2.2 Consented Scheme Comparison Proposed Scheme - Second Floor

2.2 Consented Scheme Comparison Proposed Scheme - FEC, Conference Centre & Waterpark

2.2 Consented Scheme Comparison Proposed Scheme - Porte Cochere

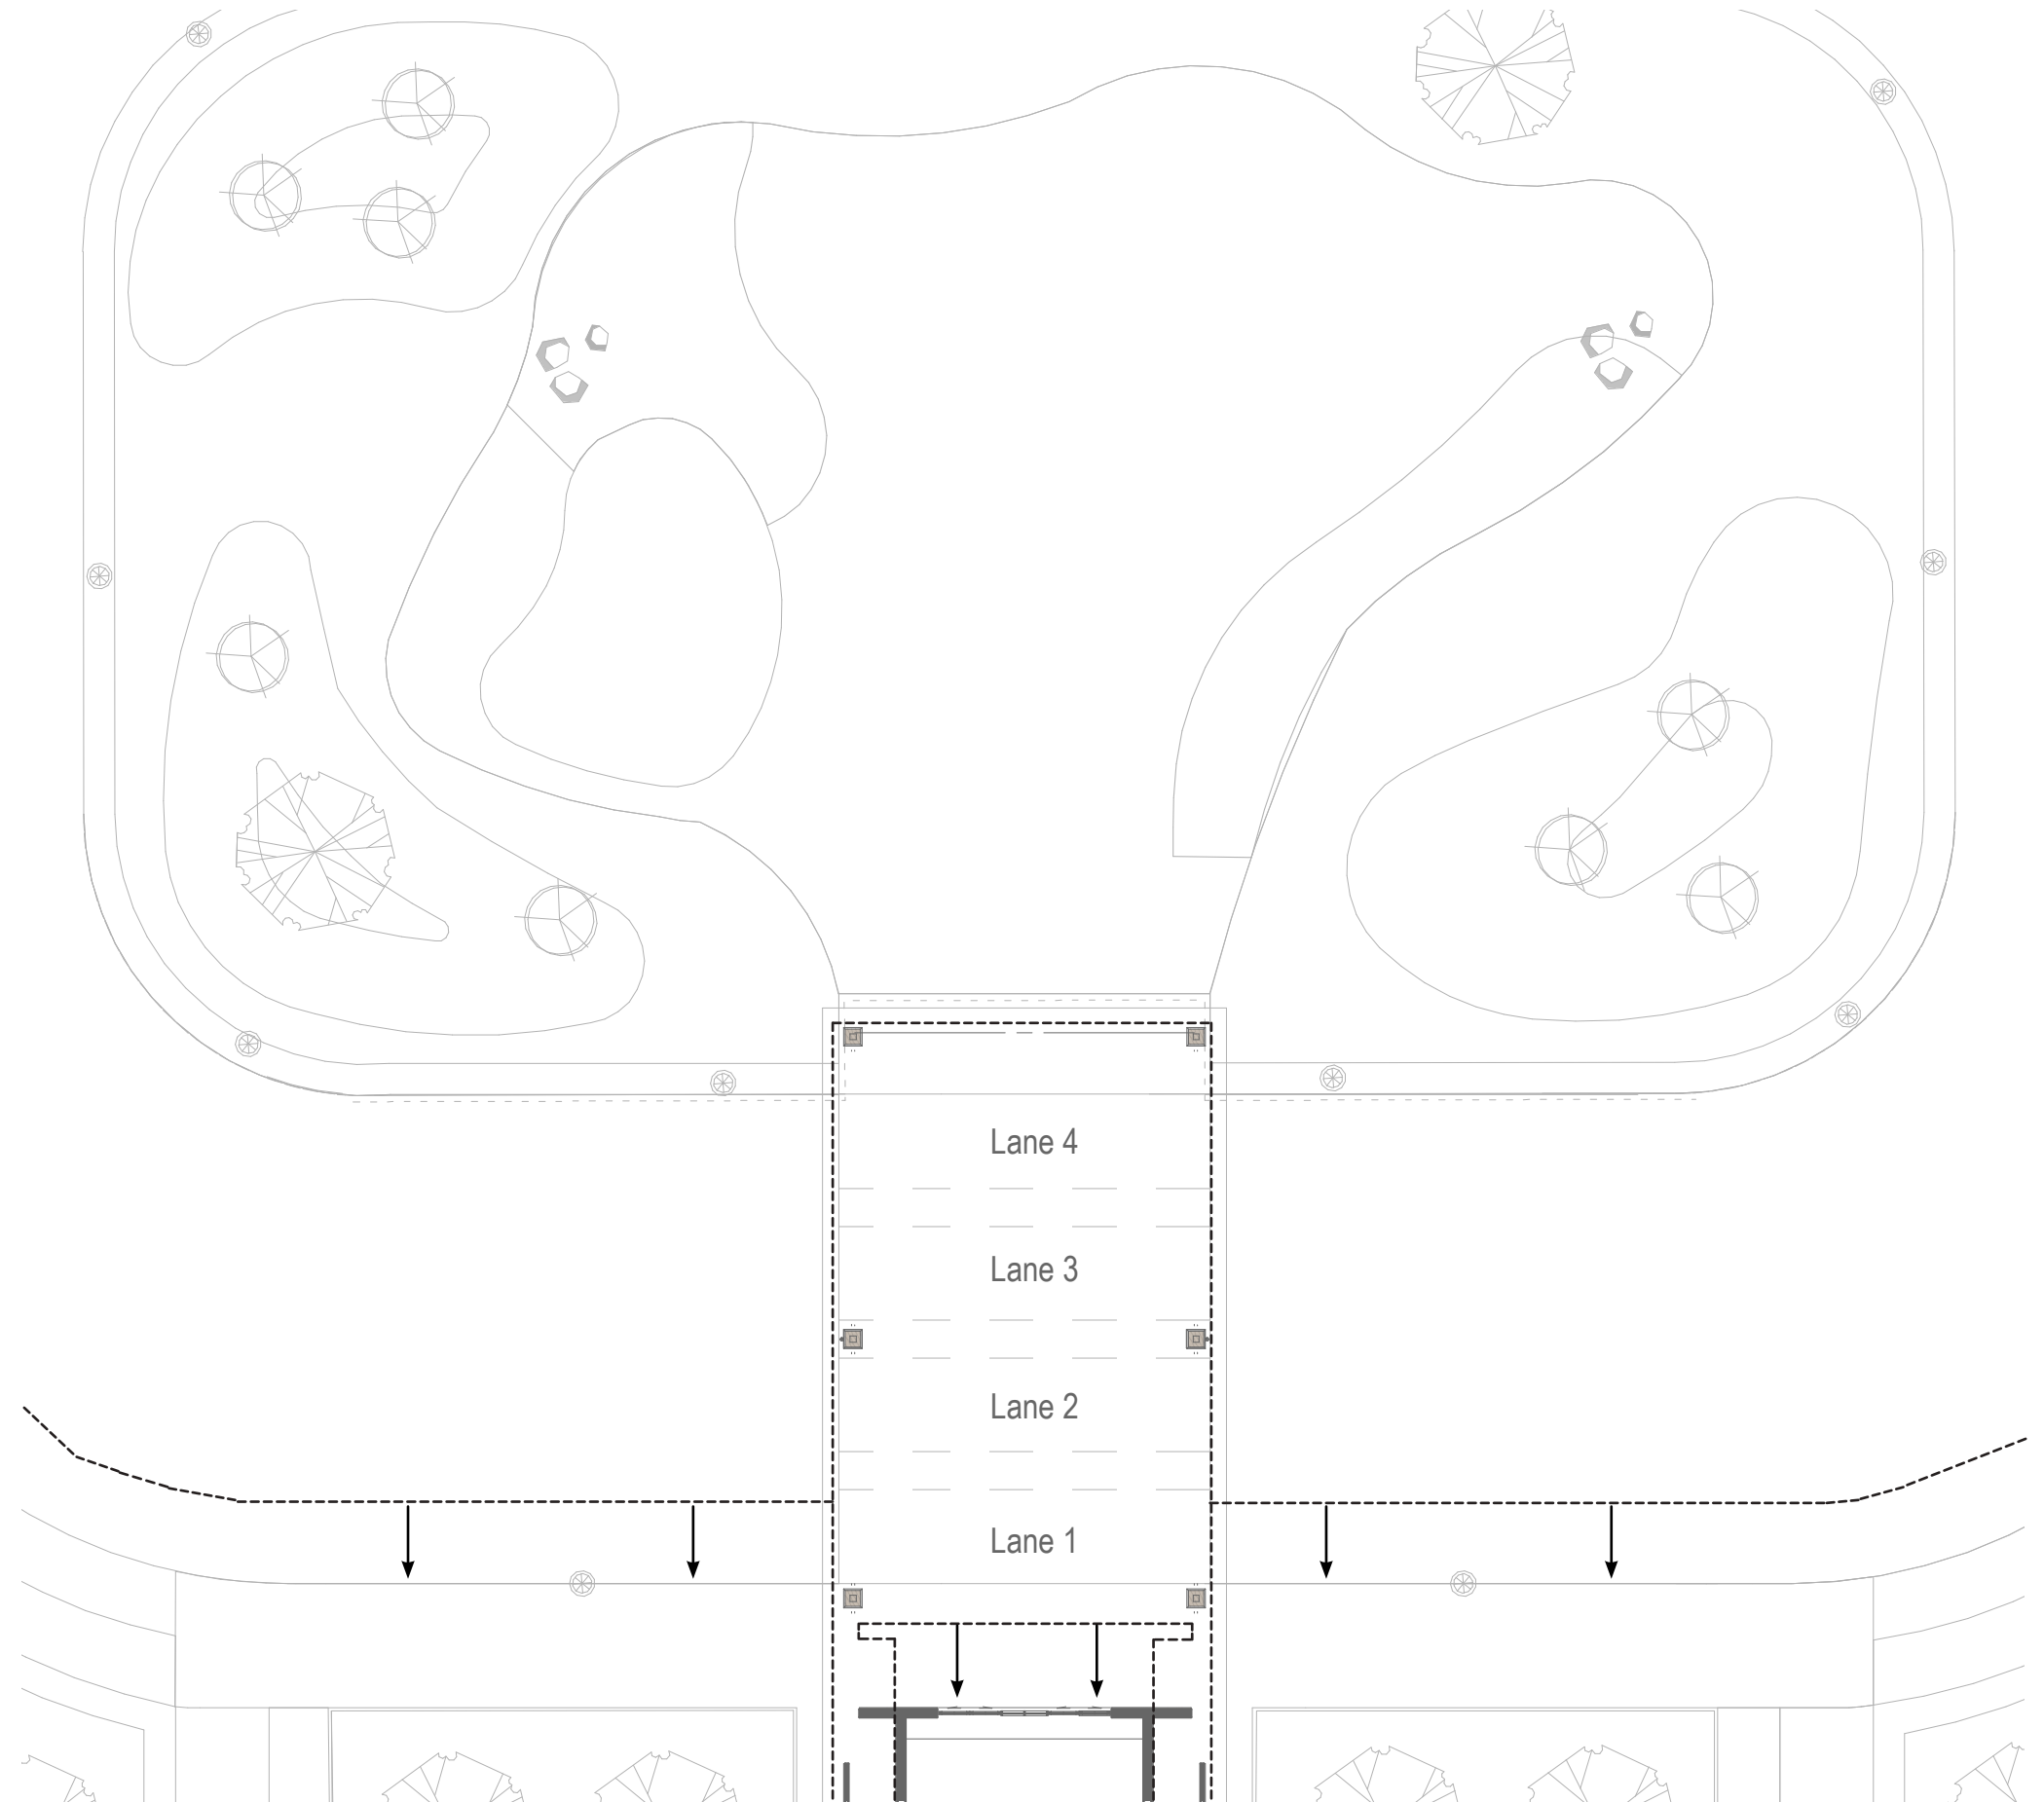
Extension of the Porte cochere as a result of shifting the building southwards 3.6m to allow for a larger drop off / set down point for arriving guest vehicles/buse.

Updates include:

- Introduction of 4 level drop off lanes and pedestrian zones.
- 3 lanes introduced within roundabout road way to split into 4 laned drop off.

Note: There is no requirement for any increase in expected guest arrival/departure vehicular activity. Proposals are in line with original planning consented strategy.

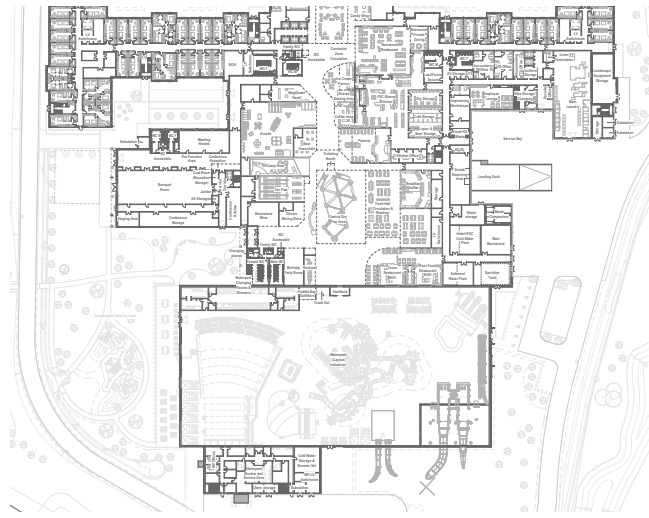
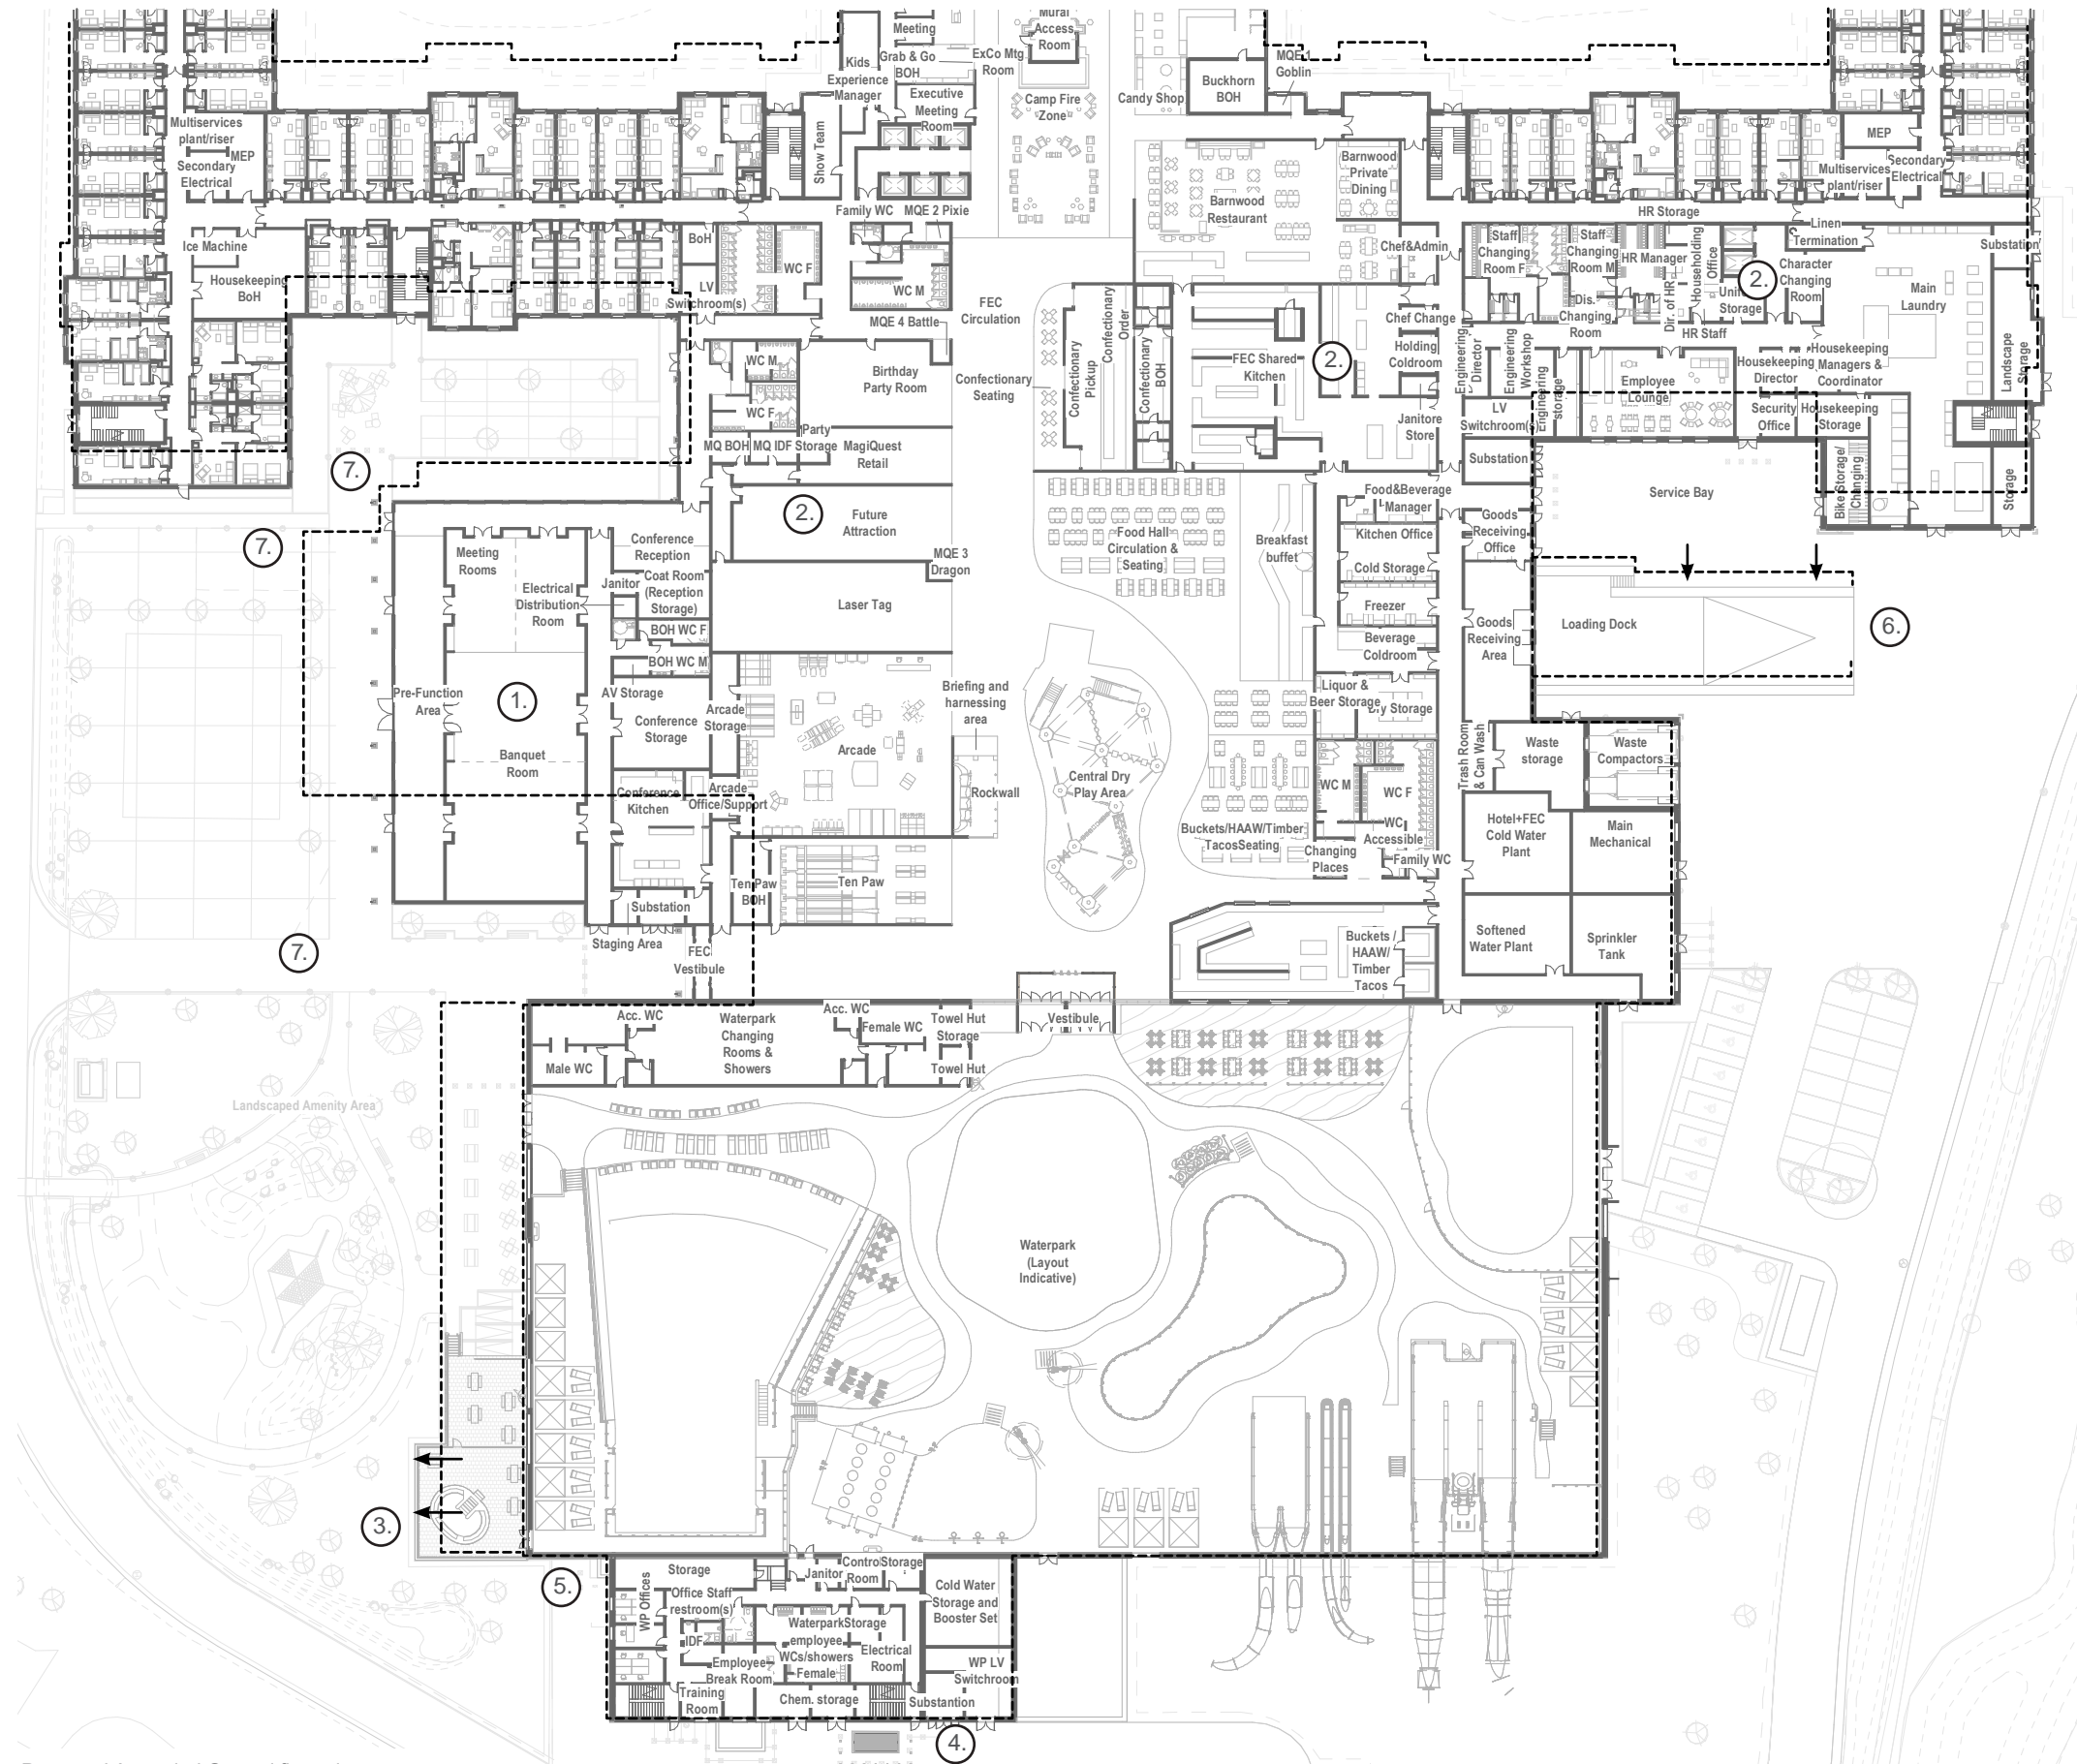
- 1. Re-configuration of the conference centre massing, facade design and internal layout. The overall reduction in the area of the FEC, Conference Centre and main BoH is approximately 1% from consented scheme.

- 2. Alterations to the number and type of leisure attractions in the FEC and updated catering & BOH layouts
- 3. External water park deck layouts revised and height levels updated to facilitate raised terrace zone with associated balustrade. Enlarged square to the South East corner created to host new outdoor whirlpool design.

- 4. External exposed Co2 storage tank to be located outside the proposed bunker building. Storage tank to be sat on a concrete plinth with perimeter bollards.

- 5. Wave fan air plenum at grade relocated on plan.
- 6. Waste yard loading bay ramp shifted 500mm closer to building envelope and concrete vehicular guarding added. Ramp increased in length.

- 7. Updates to the landscape design proposal as a result of the building footprint changes and reconfiguration of the Conference centre and fire tender access to the site. I.e. Conference centre road split off from the perimeter access road moved in line with revised conference centre design.
